# ADDENDUM

**PROJECT: Clovis Landmark Square  
Senior Activity Center and Transit Center**

**ADDENDUM#: 02**

**PUBLISHED DATE: October 30, 2020**

**UPPER ROOF FRAMING PLAN (PARTIAL)**  
SCALE: 1/8" = 1'-0"

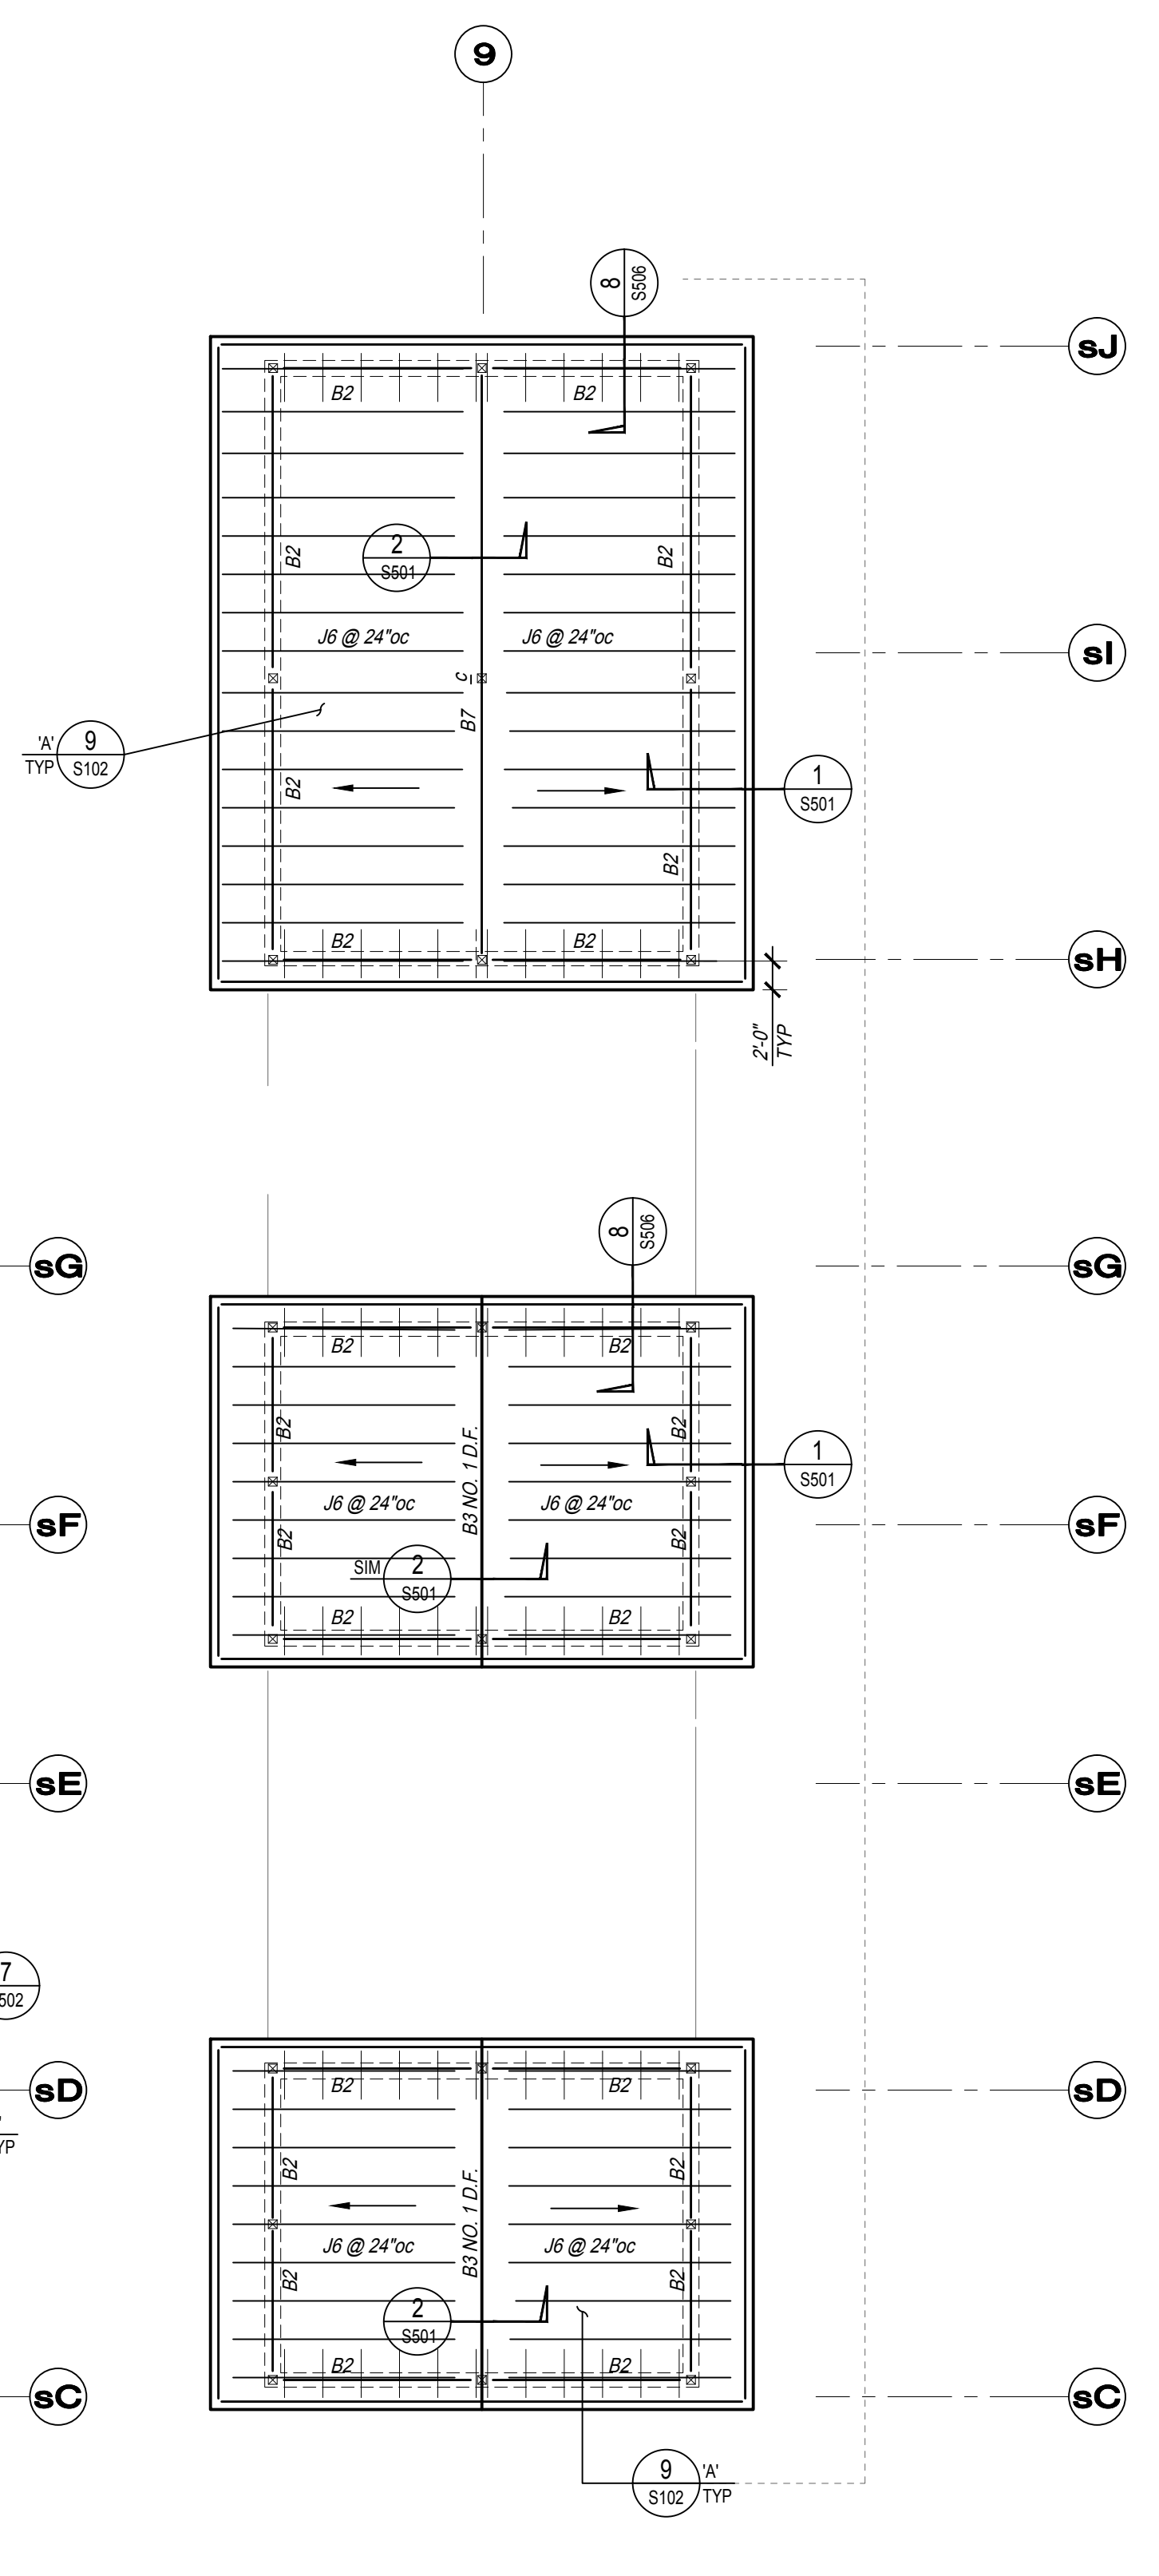
- a. Omit sheet **AD1-S300, Senior Activity Center-Roof Framing Plan** and replace with **AD2-S300, Senior Activity Center-Roof Framing Plan** attached. The following changes have been made:
  - i. Revised beam sizes each side of Grid 9 and north of Grid sA.

SHEET NUMBER:  
AD2 S301

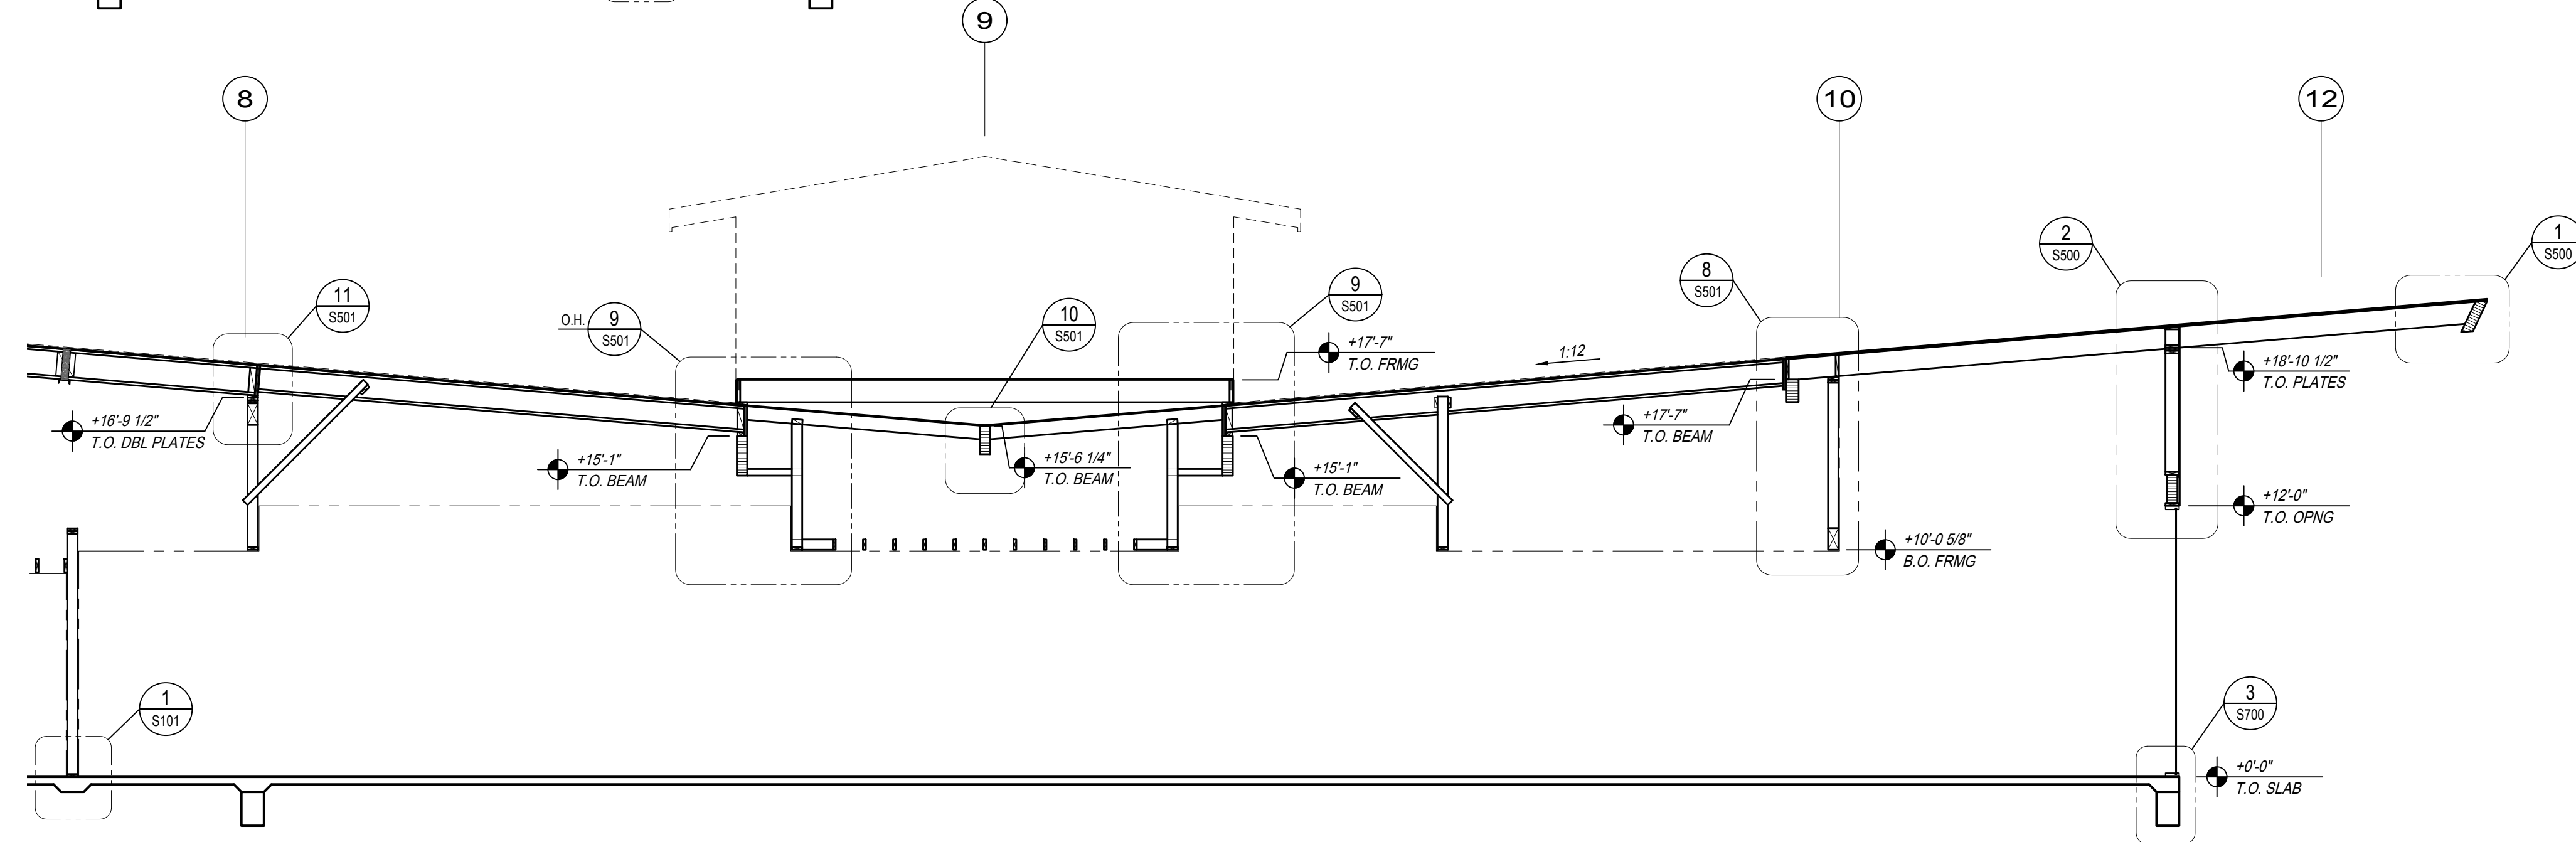
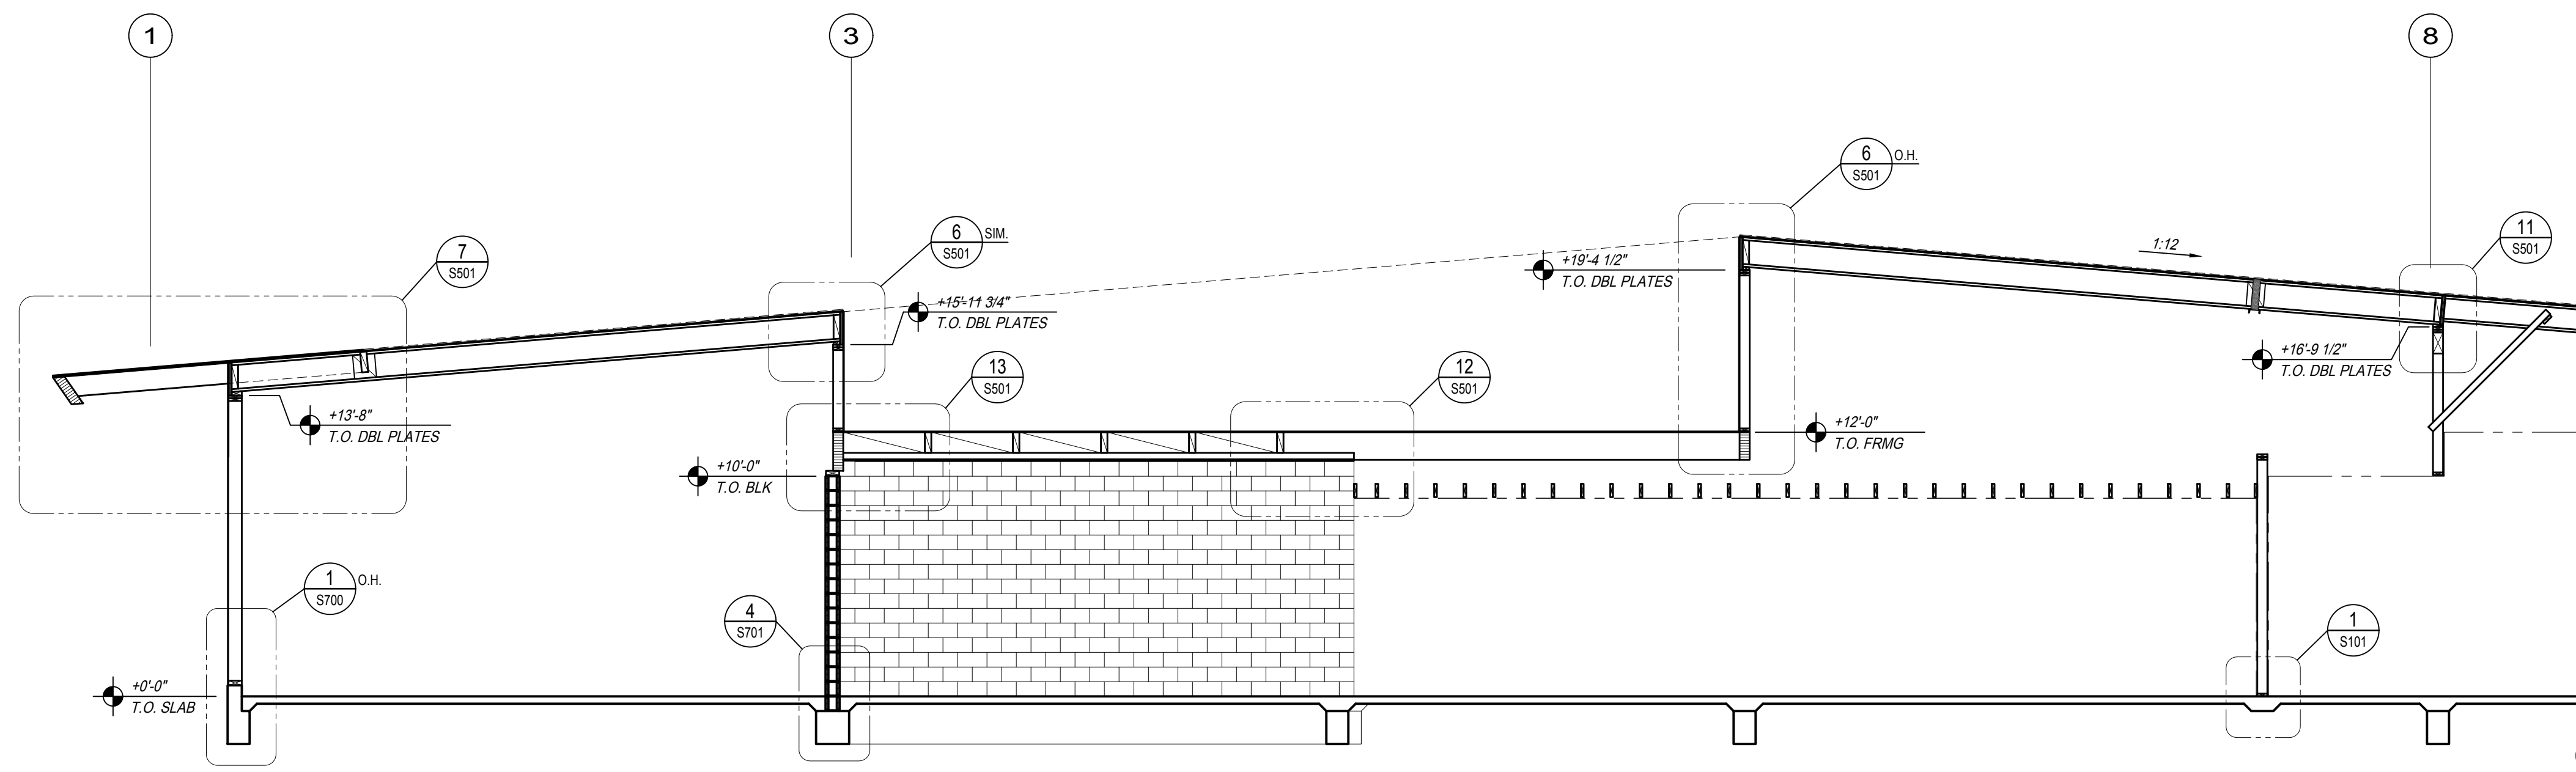
- a. Omit sheet **AD1-S301, Senior Activity Center-Upper Roof Framing Plan** and replace with **AD2-S301, Senior Activity Center-Upper Roof Framing Plan** attached. The following changes have been made:
  - i. Revised beam size for B15.

SECTION G  
SCALE: 3/16" = 1'-0"  
SC SECTION 07 S403

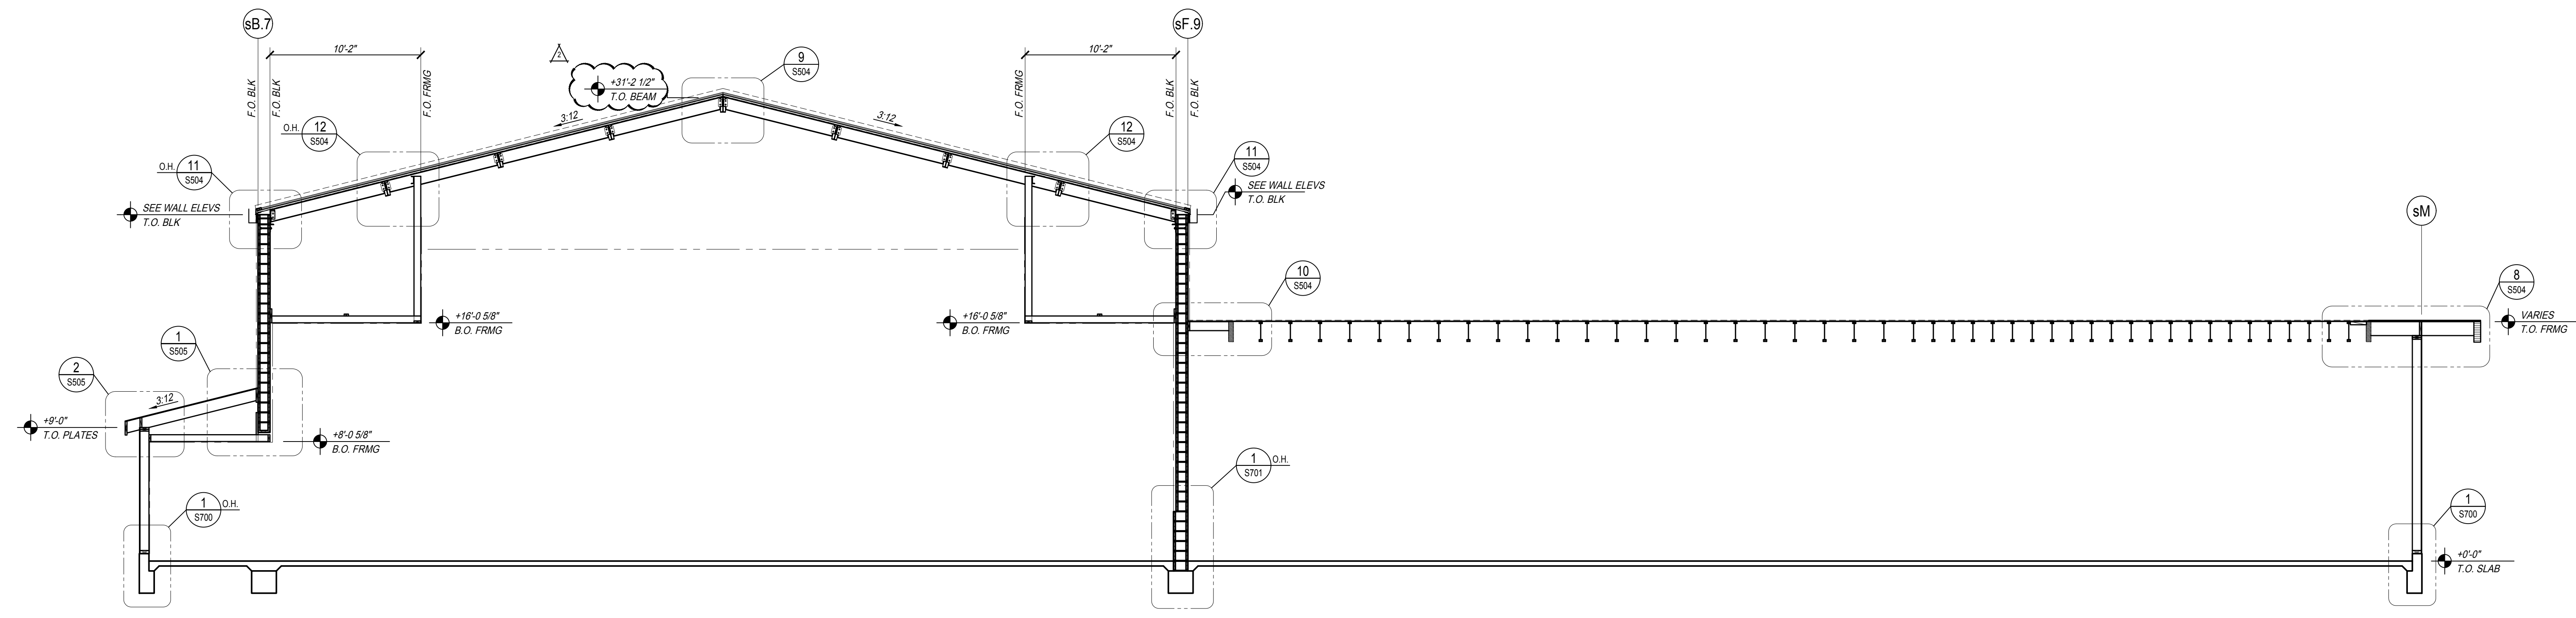
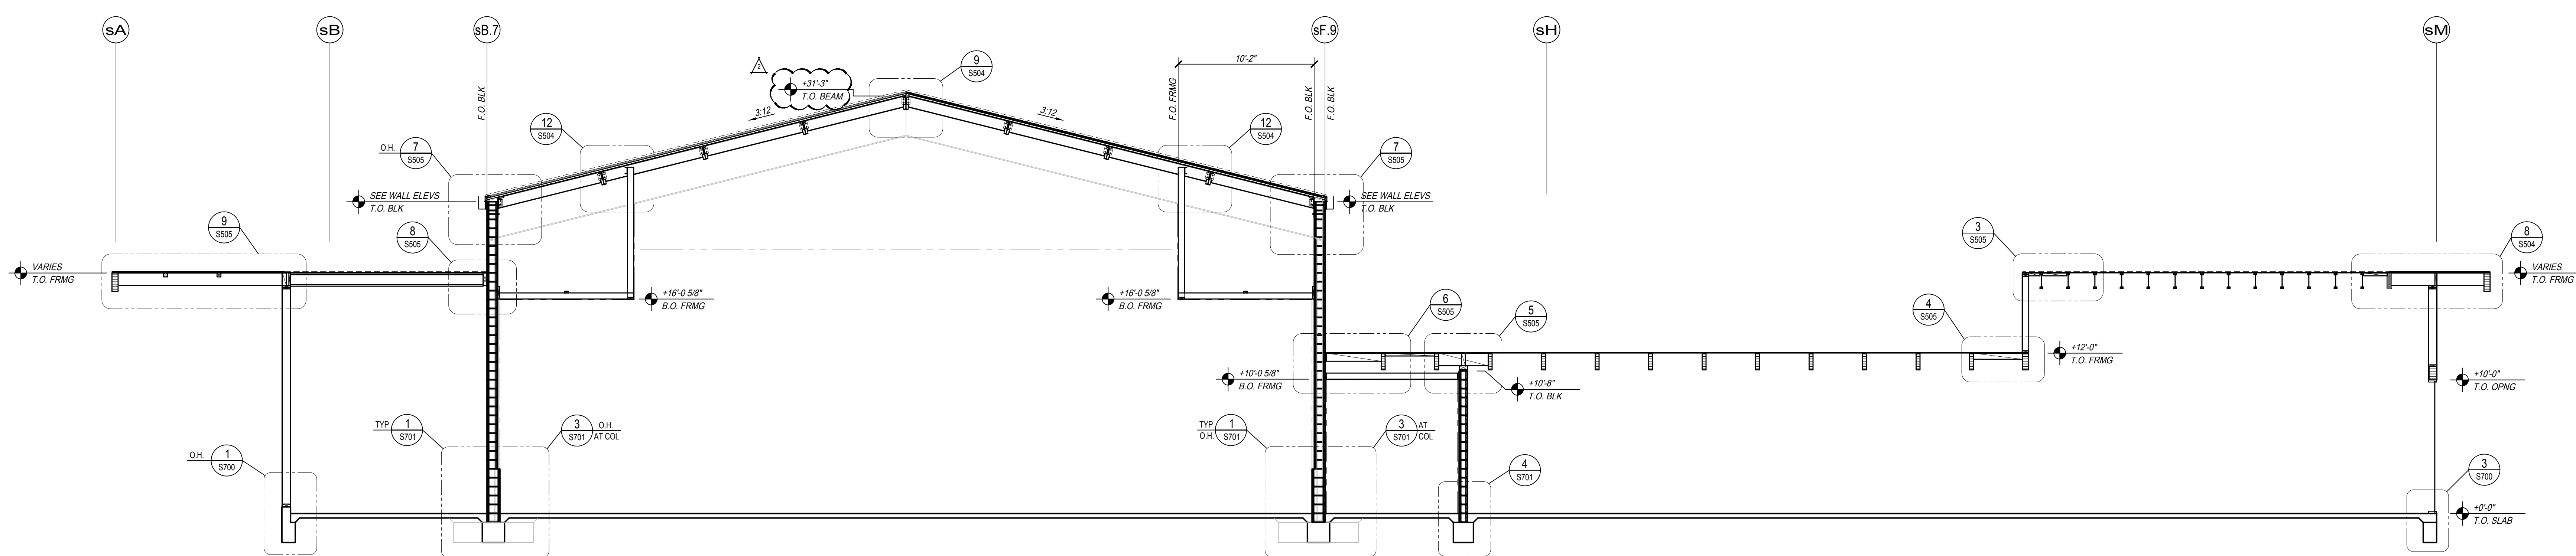
- a. Omit sheet **AD1-S403, Senior Activity Center-Sections** and replace with **AD2-S403, Senior Activity Center-Sections** attached. The following changes have been made:
  - i. Refer to section G/S403 - Added columns. Orientation of beams have been revised to vertical instead of tilted with the roof slope. Eave conditions at each side have been revised to accommodate rain gutter. Elevation of ridge beam has been revised due to change in beam size.
  - ii. Refer to section H/S403 - Eave conditions have been revised on each side.
  - iii. Refer to section J/S403 - Eave conditions have been revised on each side.
